Office Action Summary

10/622,491

ROBERTS, BRIAN

DETAILED ACTION

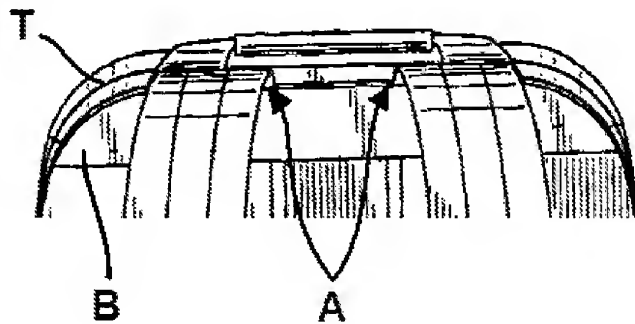
Regarding claims 38, 42, 44, 48, the back-facing face of the modified Ivarson et al. backpack has a top end (T, figure below) and the shoulder strap is connected to the back-facing face (B, figure below) at a position (A, below) spaced from the top end of the back-facing face.
